STATEMENT OF EXPERT EVIDENCE

AMENDMENT C185 BALLARAT PLANNING SCHEME and EPA WORKS APPROVAL APPLICATION

CENTRAL VICTORIAN LIVESTOCK EXCHANGE (CVLX)

SURFACE WATER MANAGEMENT

Figure 1 Revised Concept Site Layout Plan (Revision M) marked up to show the catchment drainage divide

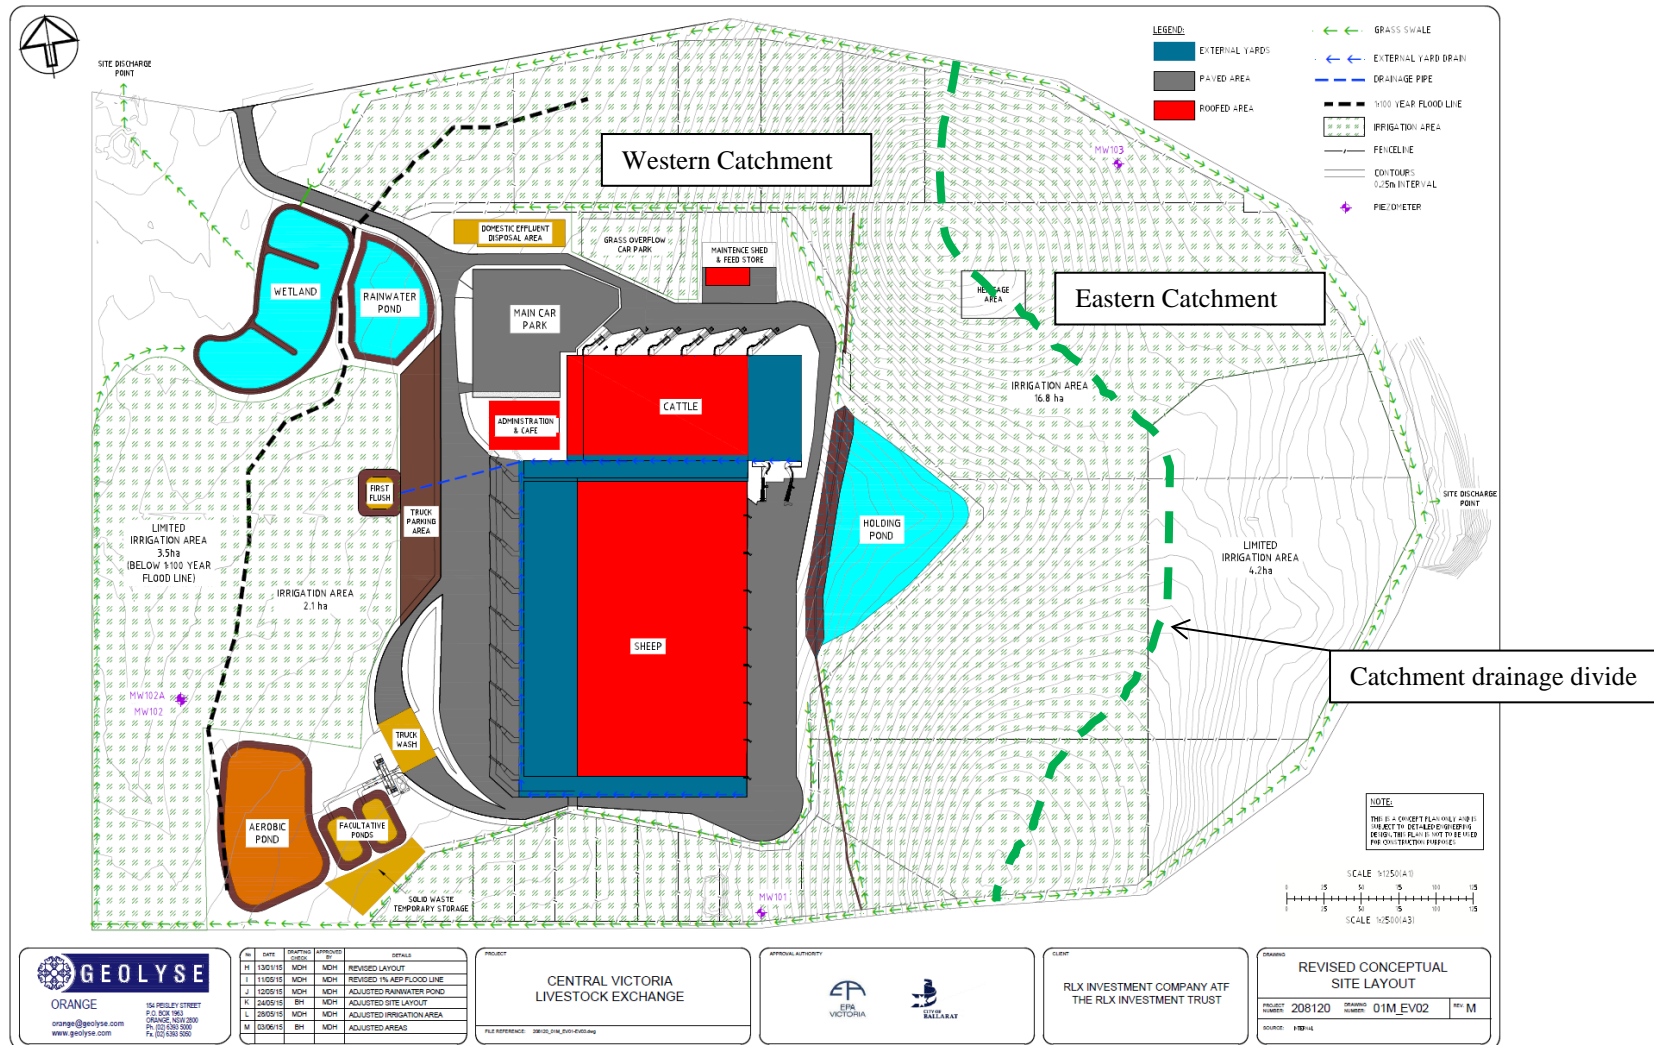
The current concept plan on Figure 1 shows the wetland being located between the 10 year ARI and the 100 year ARI flood lines. The GHCMA have advised that there would be no objection to the wetland being so located, provided that it was formed in cut below natural surface without an embankment.

In my opinion this current concept raises some issues of concern:

1. Insufficient vertical level difference will be available to create the modelled extended detention depth and flood storage depth.
 - The wetland NTWL will need to be about 410.0 m in order to gain adequate vertical clearance to the invert of the culverts under Sunraysia Highway (408.95 m).
 - The proposed west frontage of the wetland matches the 10 year ARI flood level of 410.3 m.
 - Hence there is just 300 mm vertical water level rise available before free overflow occurs to the site outfall.
 - However the modelled extended detention depth is 500 mm and the 100 year flood depth is 840 mm.
2. the performance of the wetland could not be monitored during periods when it is flooded out by external catchment floodwaters.
3. No guarantee can be provided against inadvertent overflow escaping from the system when flooded out.

There are two options available to resolve these concerns:

- a) Provide a confining embankment to separate the wetland from the floodplain and ensure the extended detention and flood storage depths are fully contained on the east side.

- b) Relocate the wetland either north or south with its westerly edge set no lower than the 100 year floodline.

Whilst either option will satisfy all key drainage and floodplain management requirements, it is my opinion that Option (a) is the best approach for the following reasons:

Figure 2 Option (a) Suggested Amendment to Wetland Concept

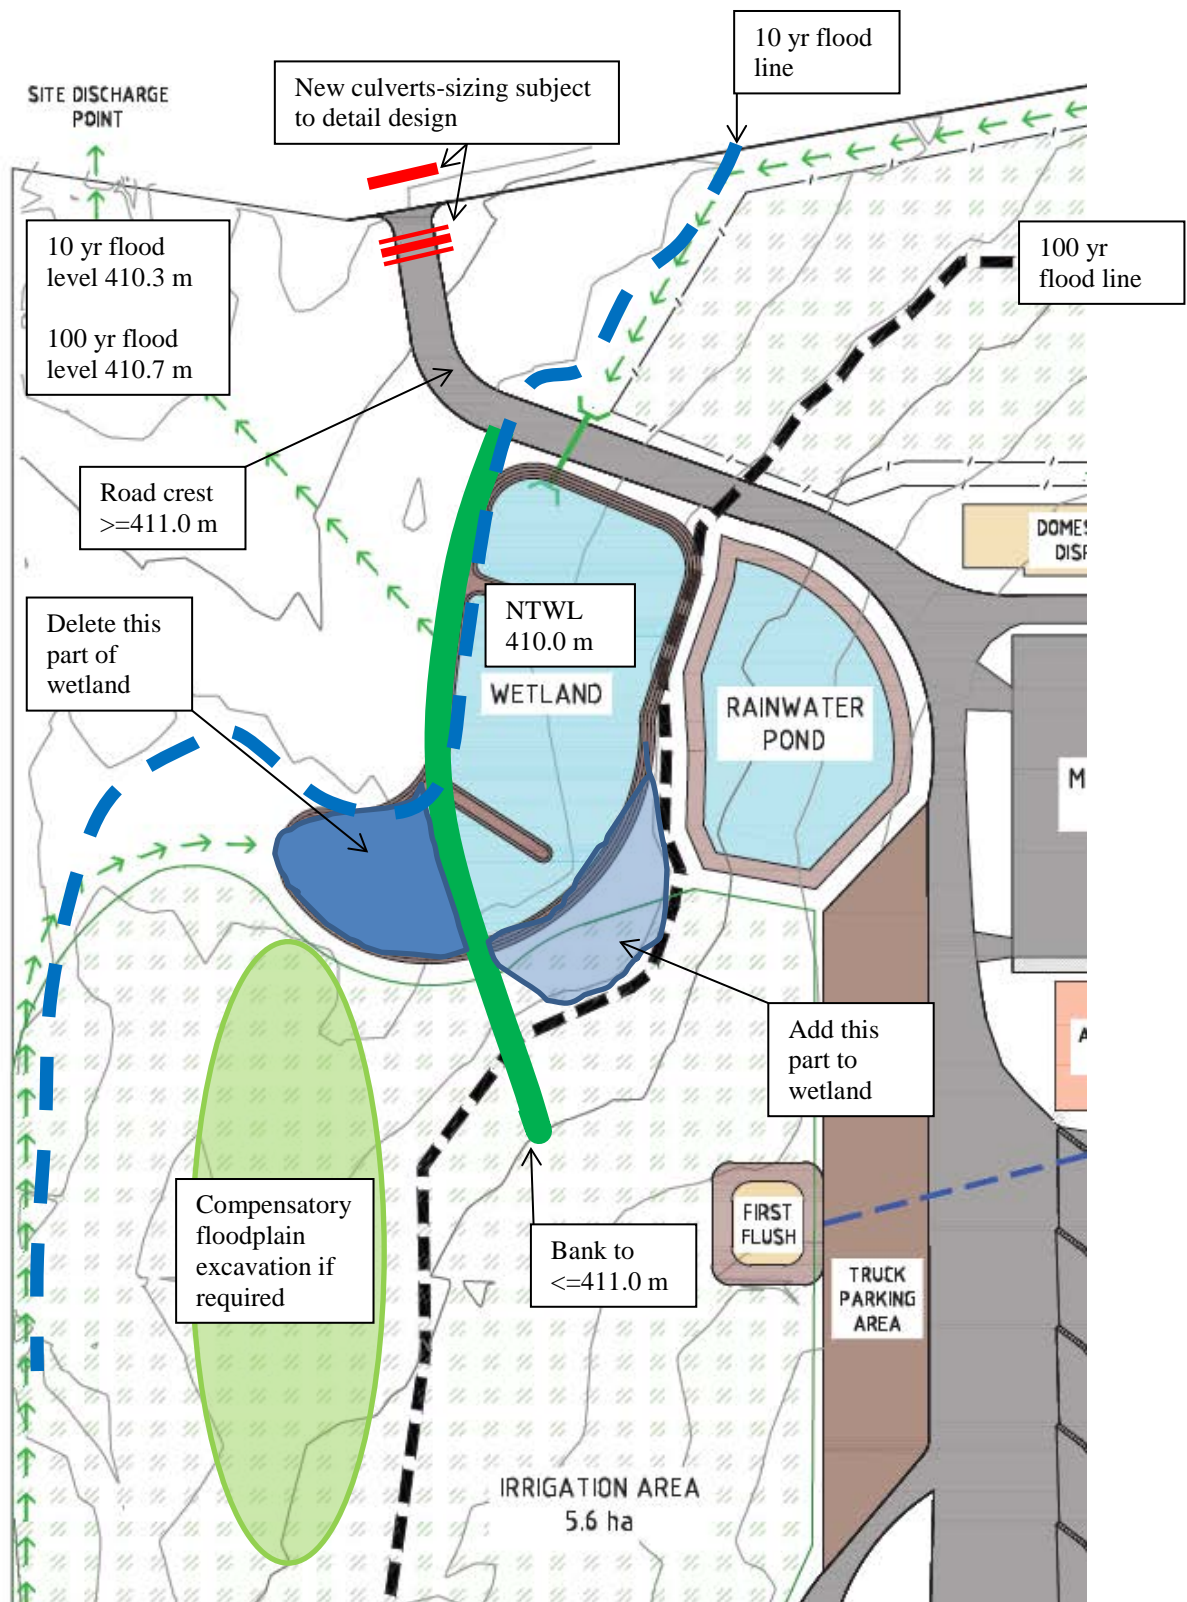
The opportunity is there to reshape the wetland and provide the embankment across the backwater zone to maximum crest level of 411.00 m, as indicated on the extract from the Site Concept Layout shown on Figure 2 below.

If required by GHCMA, compensatory earthworks can be carried out within the floodplain to maintain active flood storage volumes at relevant levels. An indicative area that could be excavated to balance volumes above the 10 year ARI event is shown on Figure 2.

Figure 3 Option (b) Relocated Wetland

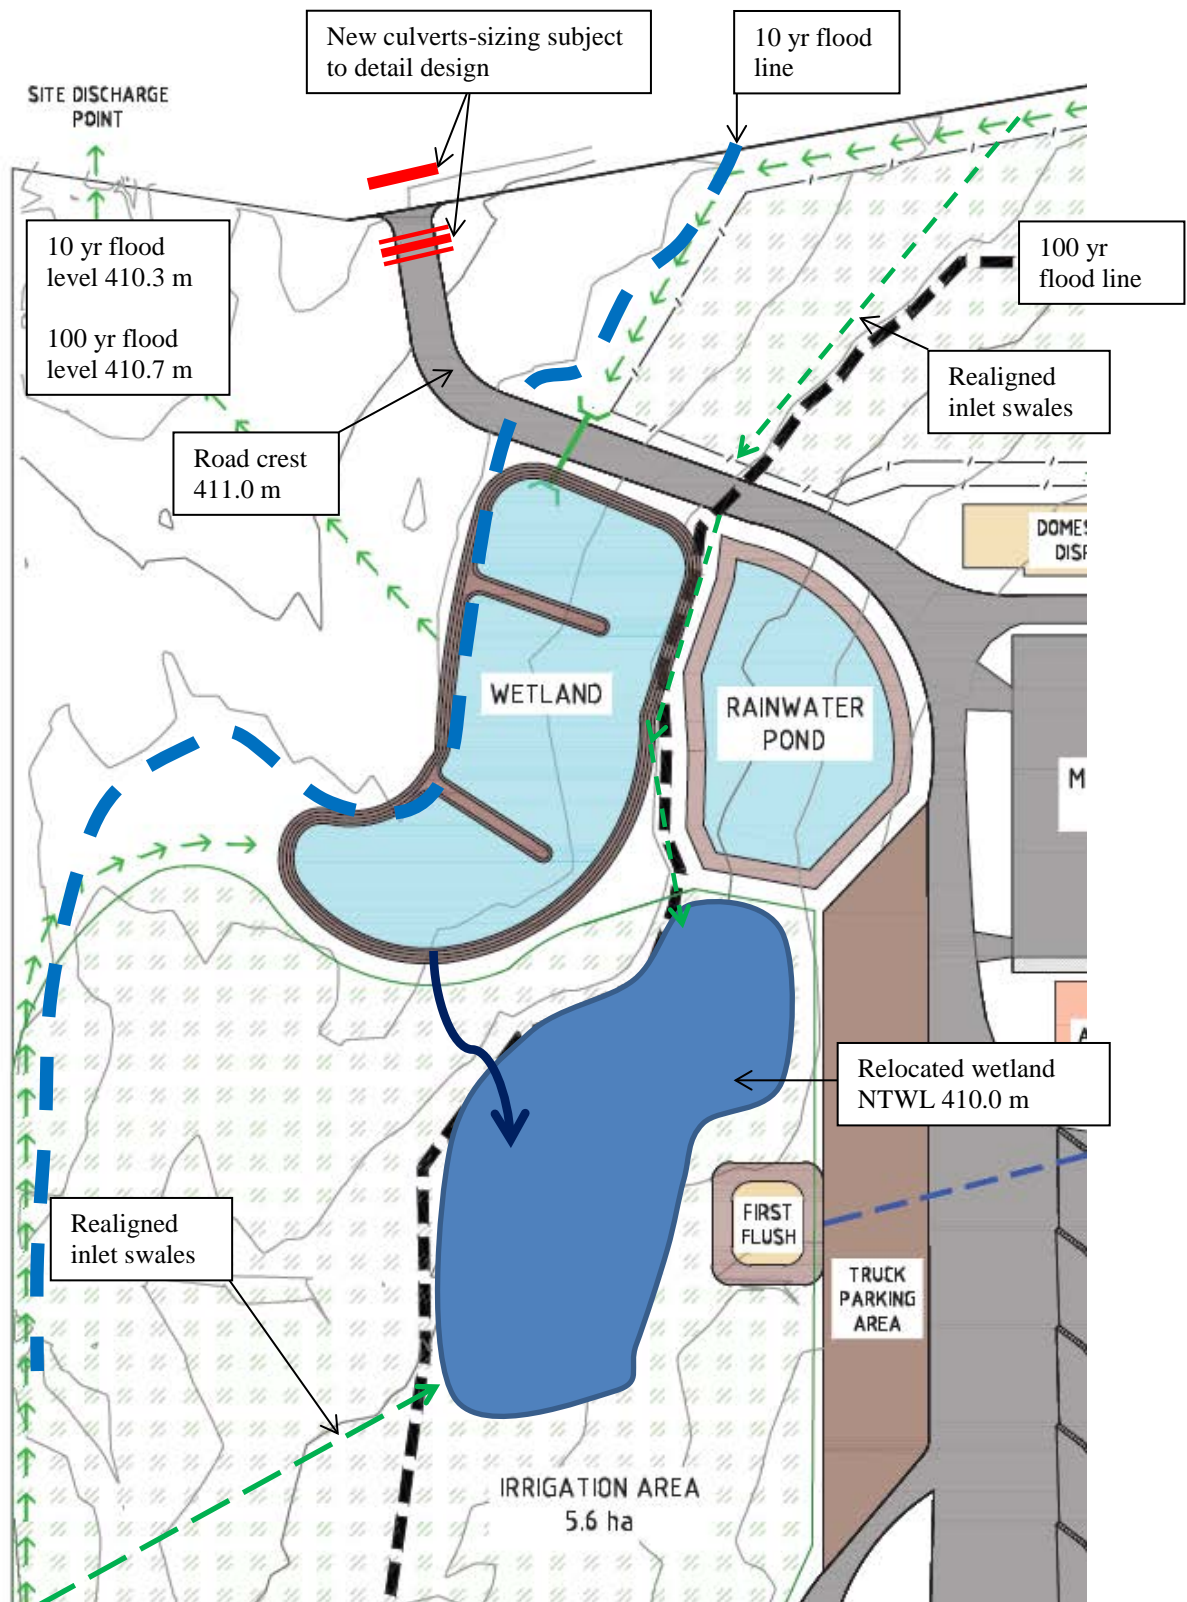
If Option (a) is not approved then one possible arrangement for the alternative Option (b) is shown on Figure 3.
